Project T10/1559-D

Revision 19
12 November 2007

Information technology - SCSI Enclosure Services - 2 (SES-2)

Summary of Comments on SCSI Enclosure Services - 2 (SES-2)

Figure 3 — Attached enclosure services process

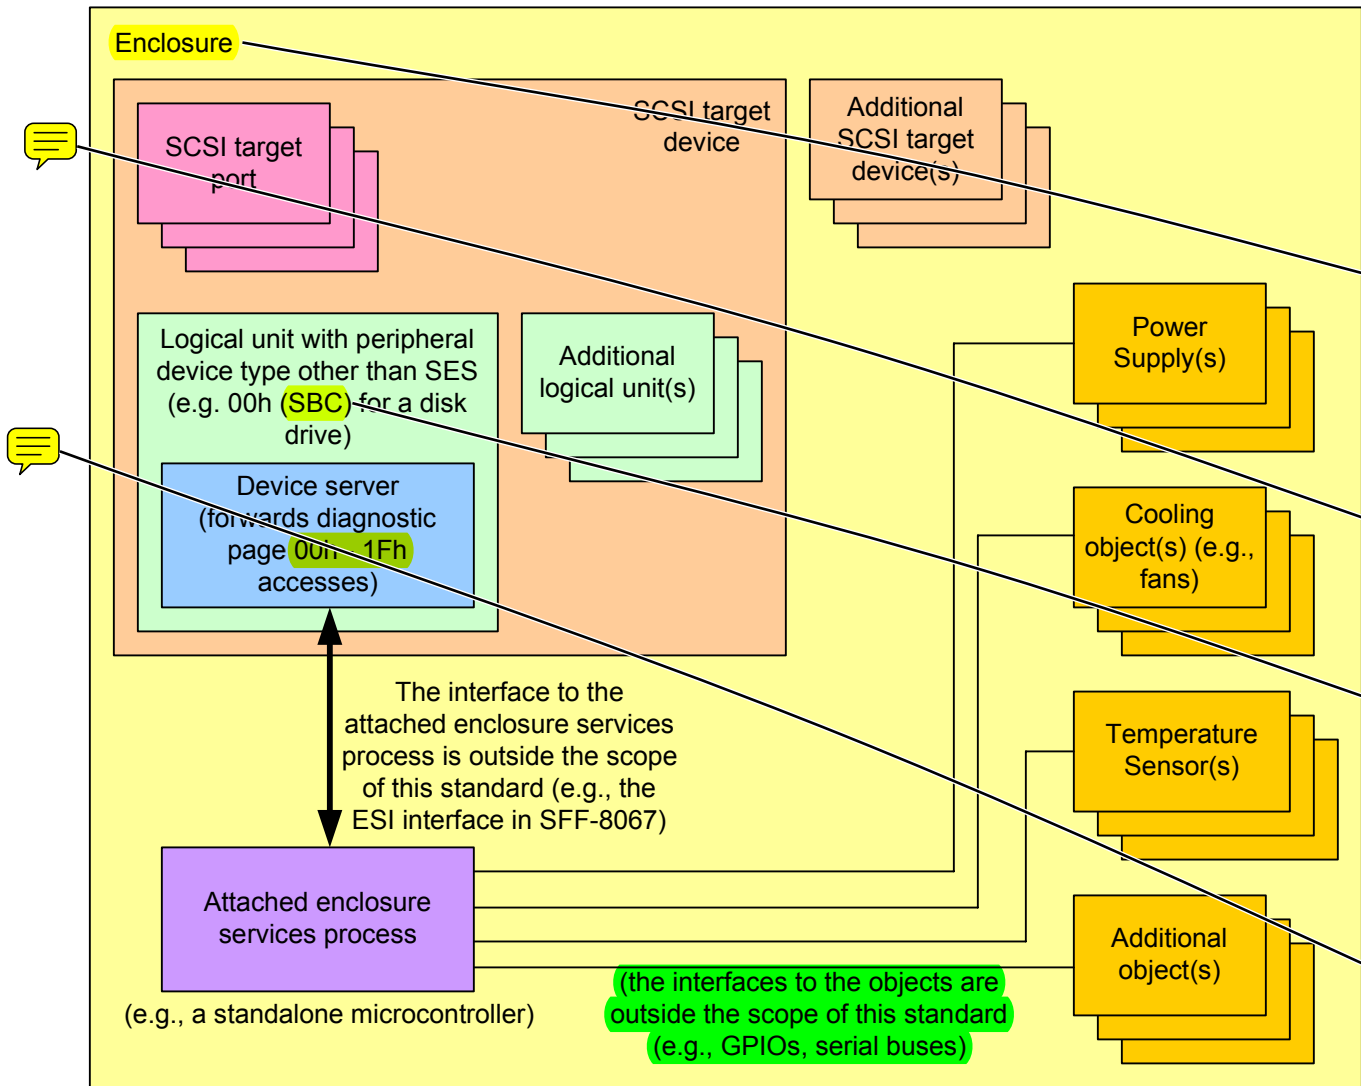
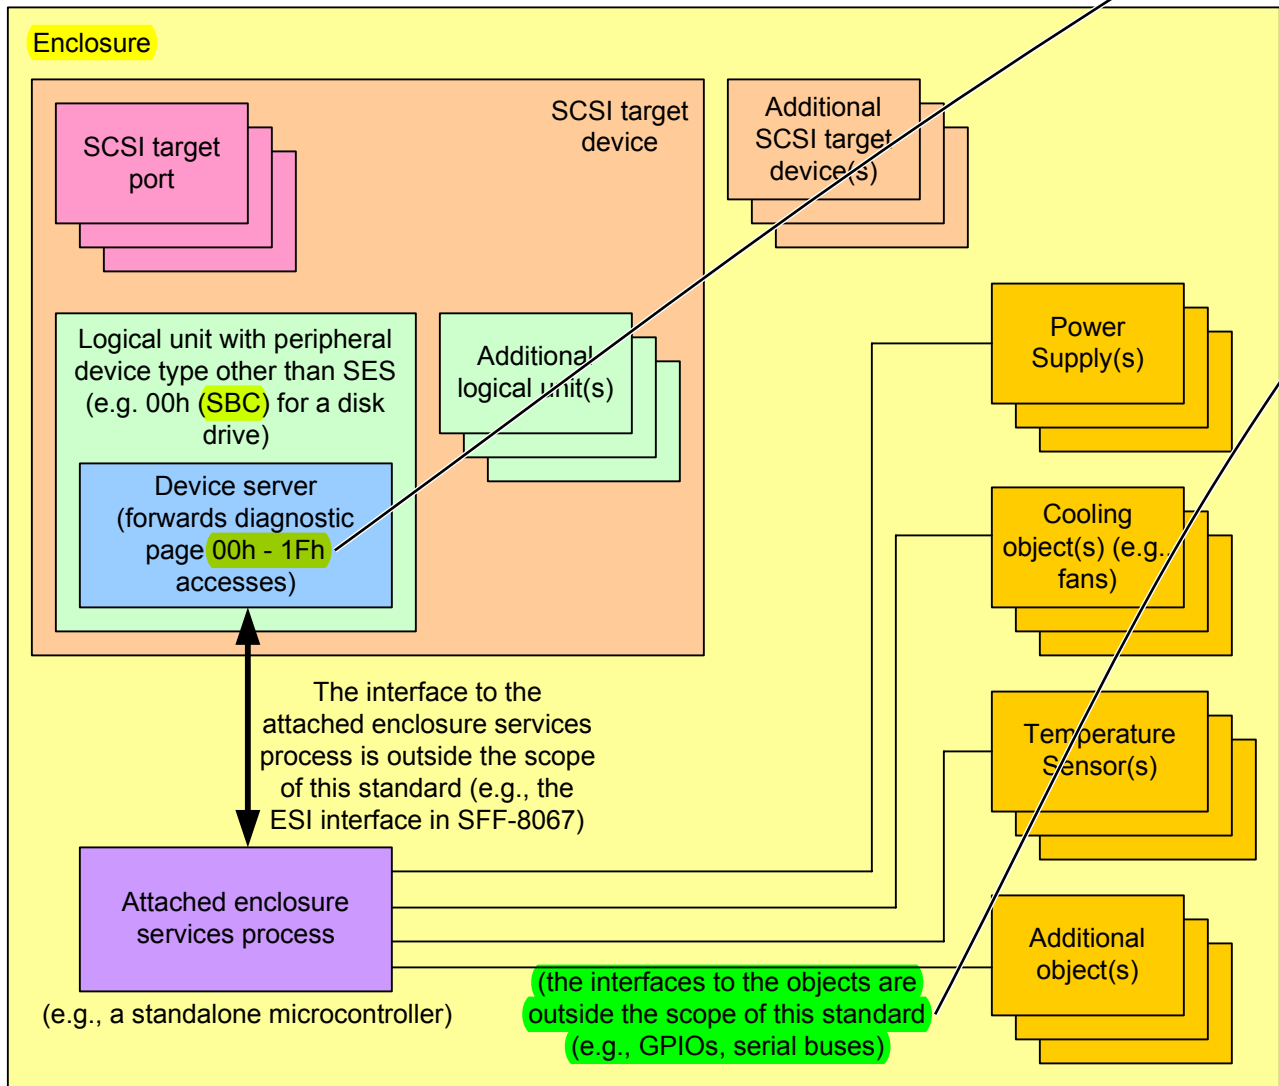
● Author: relliott
Subject: Note
Date: 1/2/2008 7:32:55 PM -06'00'
 Show the enclosure boundary not wholly containing the SCSI target device

● Author: symc-roger
Subject: Note
Date: 12/13/2007 8:25:13 PM -06'00'
 SYMANTEC 11
PDF pg 28, pg 10, Figure 3

Figure 4 — Subenclosures

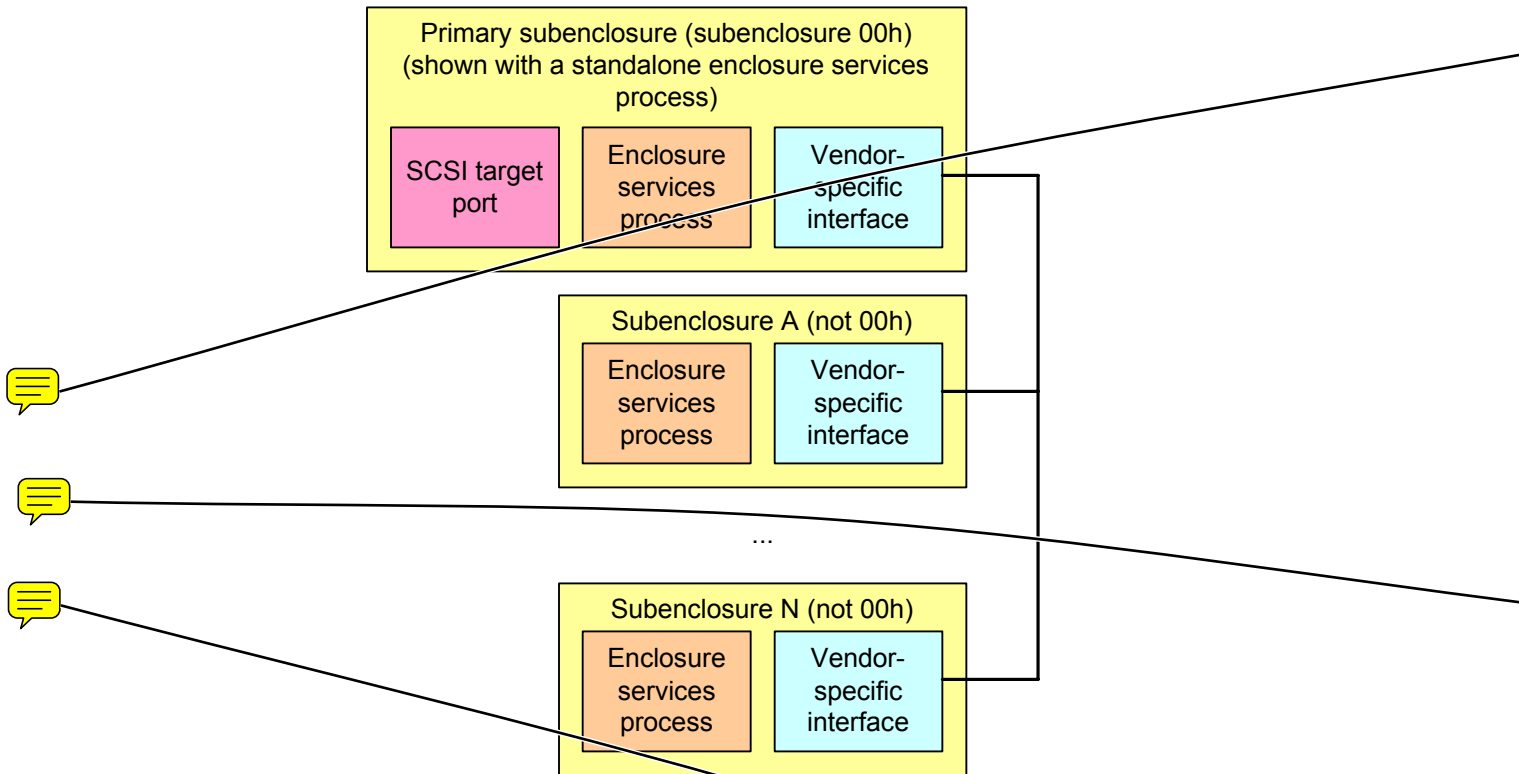
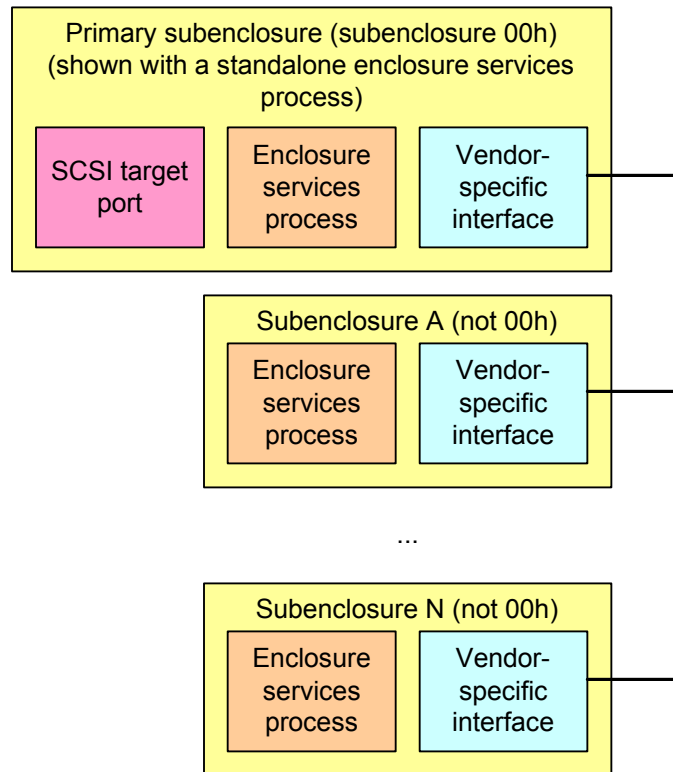
● Author: symc-roger
Subject: Note
Date: 12/13/2007 8:25:13 PM -06'00'
 SYMANTEC 18
PDF pg 31, pg 13, Figure 4

The enclosure descriptor of the configuration diagnostic page supports multiple enclosure service processes per subenclosure, and this should be reflected in the figure.

● Author: symc-roger
Subject: Note
Date: 12/13/2007 8:25:13 PM -06'00'
 SYMANTEC 19
PDF pg 31, pg 13, Figure 4

The figure is the only place that indicates that the subenclosure identifier of the primary subenclosure should be 00h.

Also, added a Enclosure box to the figure surrounding all the subenclosures.

added new section and new figure showing that. It's too complicated to overlay that with multiple subenclosures (which would then demand that standalone/attached be included as well).

Prepend the following sentence to the second paragraph after the figure: "The subenclosure identifier of the primary subenclosure shall be 00h."
